2026/2/24

三協オイルレス工業株式会社

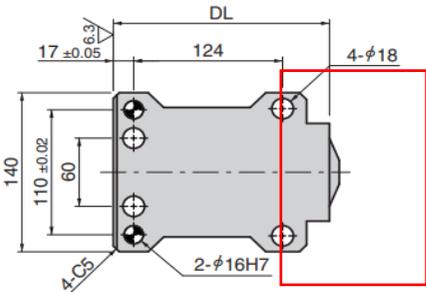
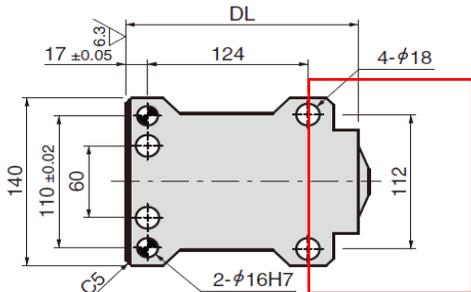
ページ	品名	誤	正
PDF 17	VACPEL140	<p data-bbox="716 663 896 689">四面図差し替え</p>  <p>The drawing shows a cross-section of a mechanical part with the following dimensions: total width 140, distance from left edge to centerline 110 ± 0.02, distance from centerline to right edge 60, distance from left edge to first hole 17 ± 0.05, distance between holes 124, and distance from centerline to right hole 4-φ18. The left side has a chamfered edge with a 4C5 chamfer and two holes labeled 2-φ16H7. The right side is enclosed in a red box.</p>	 <p>The drawing is identical to the '誤' (Incorrect) version but includes a vertical dimension of 112 on the right side, enclosed in a red box.</p>
